FLYING HORSE NORTH FILING NO. 3
CONSTRUCTION DOCUMENTS

CONSTRUCTION DOCUMENTS
OVERALL SITE PLAN

FLYING HORSE NORTH FILING 3
PRI #2, LLC.
EL PASO COUNTY, CO

TYPICAL DETAIL – 2.0' TRICKLE CHANNEL

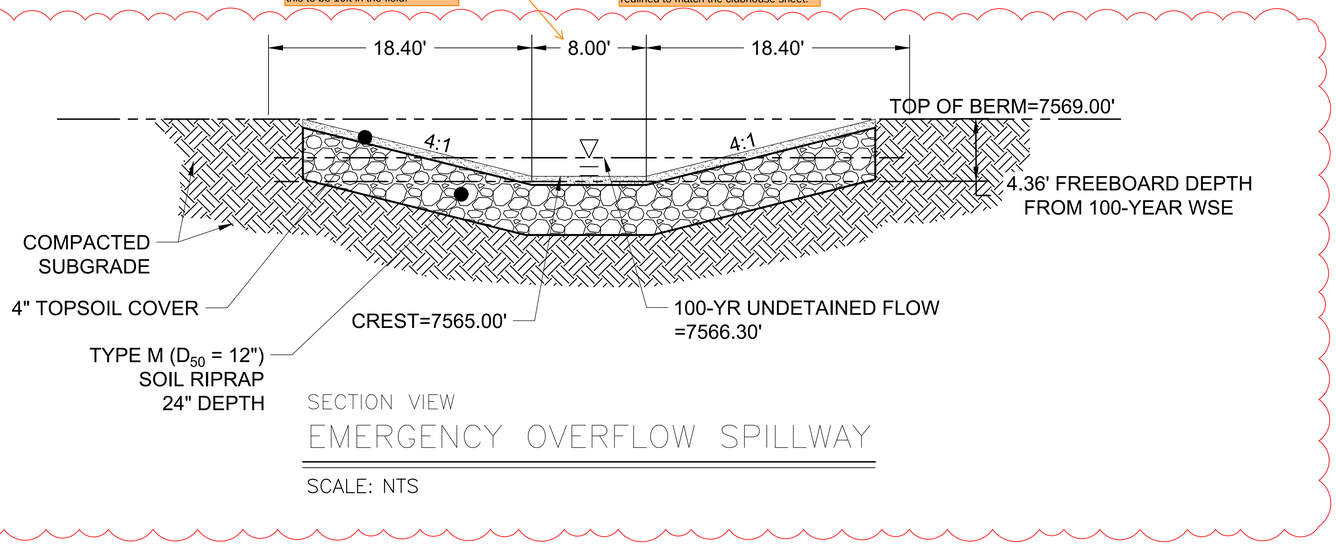
This redlined detail, the original clubhouse detail, and the original clubhouse calcs all show this as 8ft. But the as-built calcs that you submitted with the pond cert letter for this pond show this dim as 16ft. Revise to remove discrepancy.

Why have that sheet when you already redlined everything accordingly on these Filing 3 sheets? Having the clubhouse sheets would only make sense if you were crossing out these details (like you did with the forebay notch detail on the next sheet) and referring to the attached clubhouse sheets for the redlines. But the details on this sheet have been redlined to match the clubhouse sheet.

ELEVATION VIEW
FOREBAY WINGWALL REINFORCEMENT DETAIL
SCALE: NTS

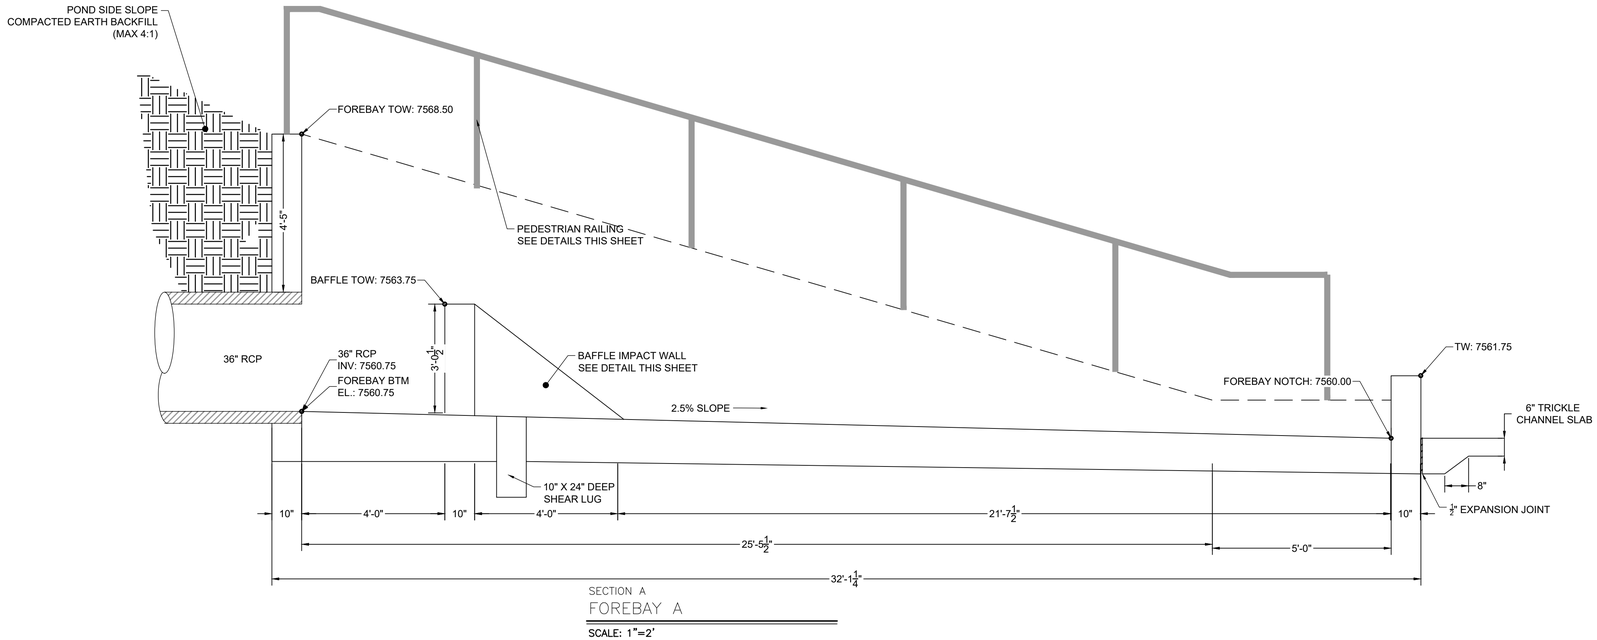
Per my comment on the previous sheet just redline this detail on this sheet so you dont have to reference or include the clubhouse sheet. For this detail, only two dimensions need to be redlined, so it will be quick/easy.

TYPICAL SECTION – MAINTENANCE ROAD

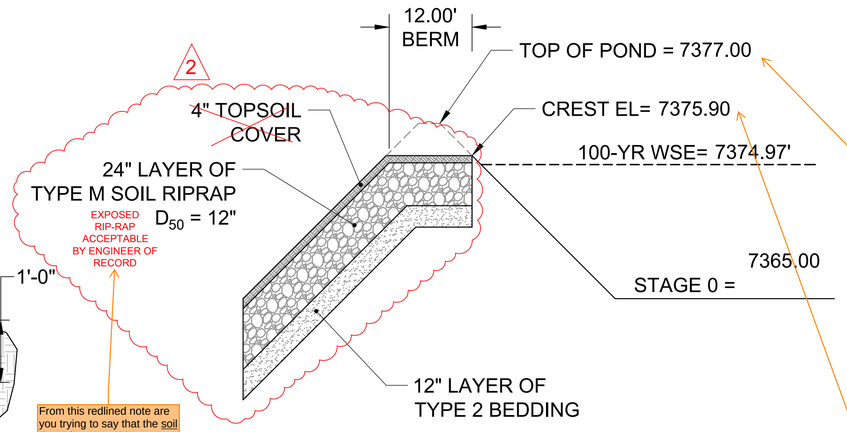
From this redlined note are you trying to say that the soil riprap is acceptable to not have the 4" of topsoil cover that you have crossed off (if so, add the word "soil")? Or are your trying to say that the soil riprap was actually installed as plain riprap (if so, cross of the word "soil" from the original black text).

TYPICAL DETAIL – 2.0' TRICKLE CHANNEL

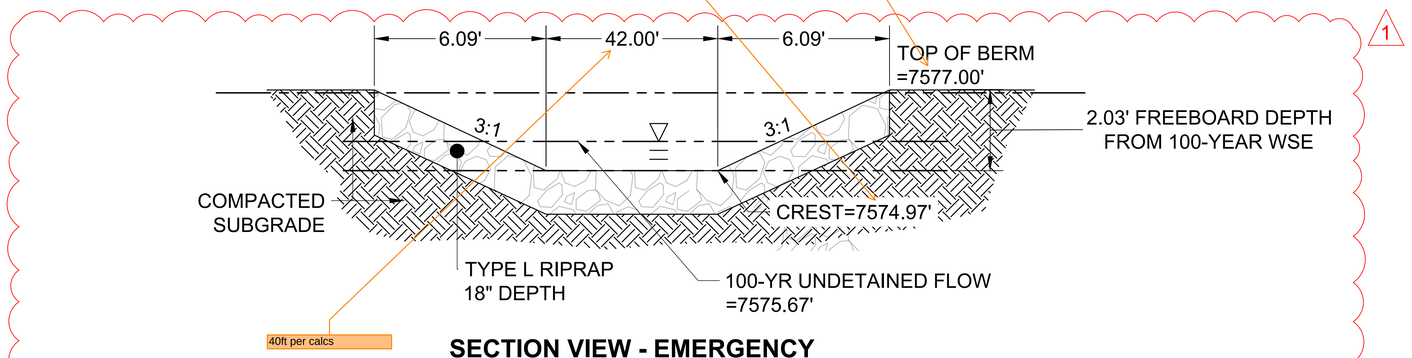
7375.90 per calcs

ELEVATION VIEW
D TRASH SCREEN
SCALE: 3/4" = 1'

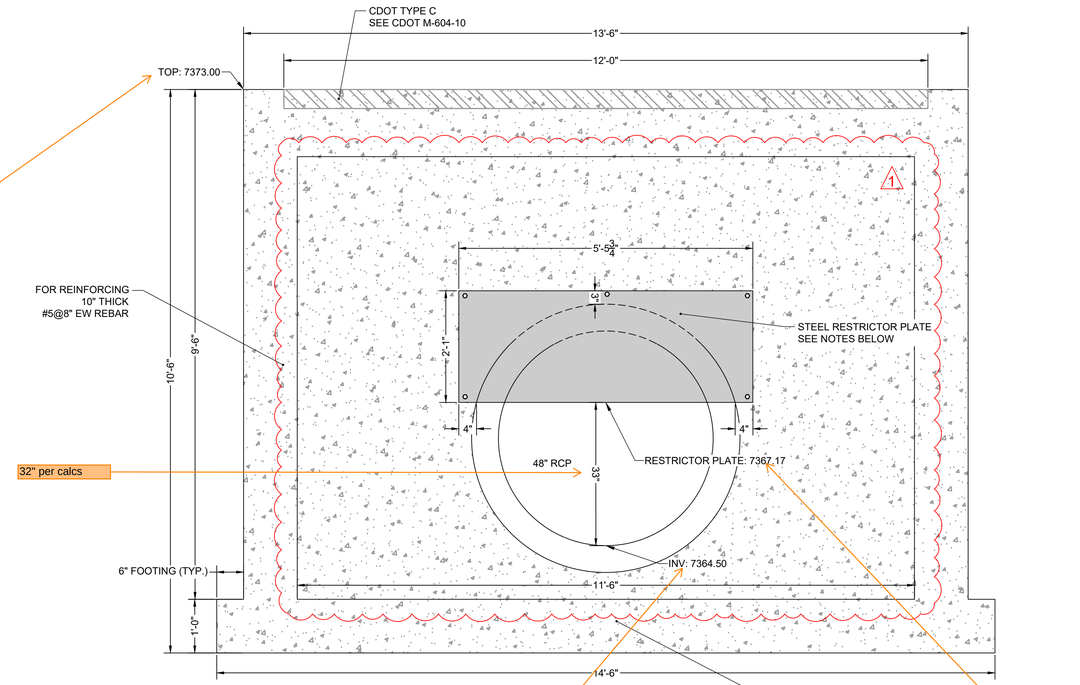
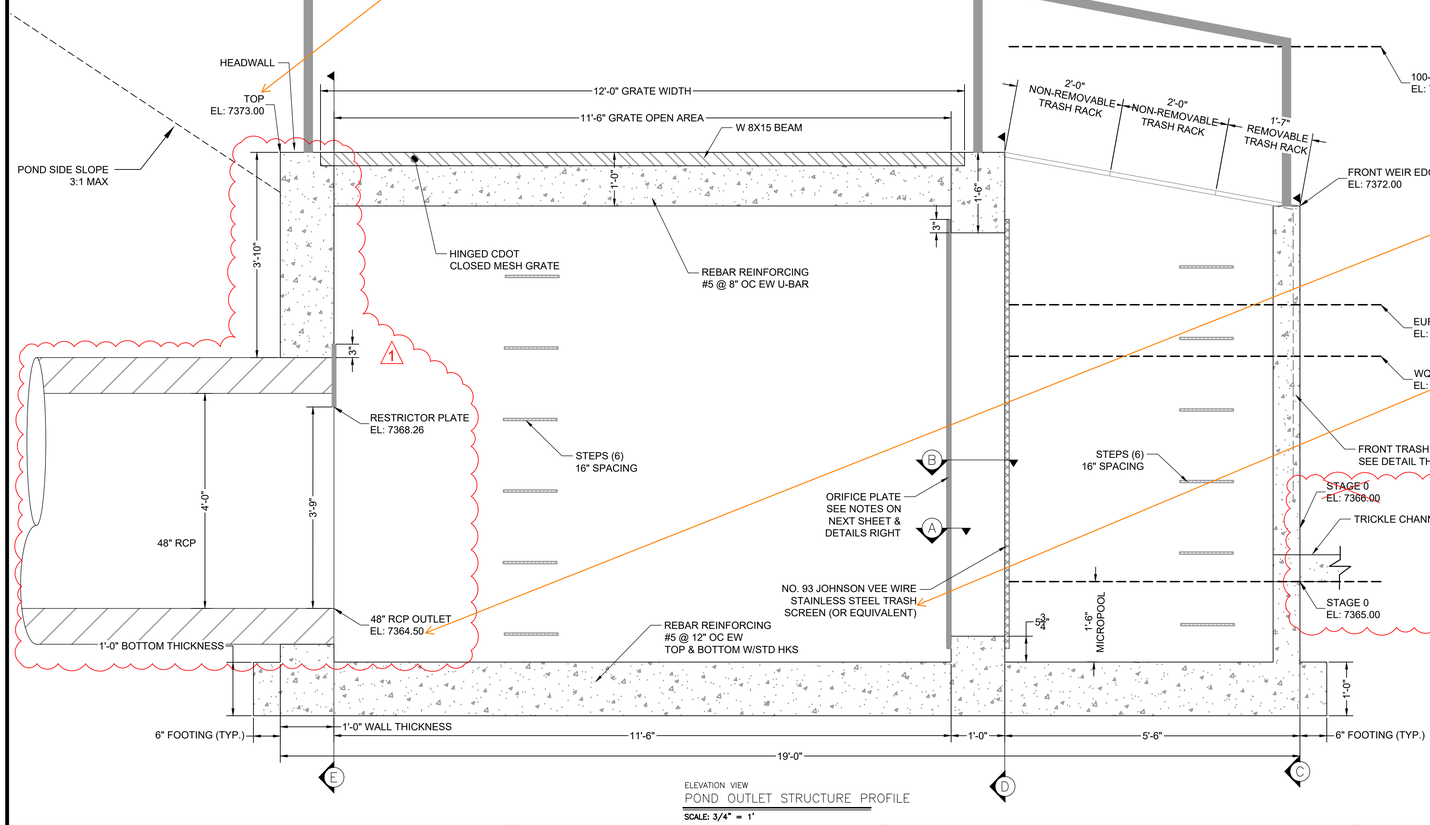
7373.16 per calcs (8.16ft above Stage = 0ft)

7367.12 per calcs
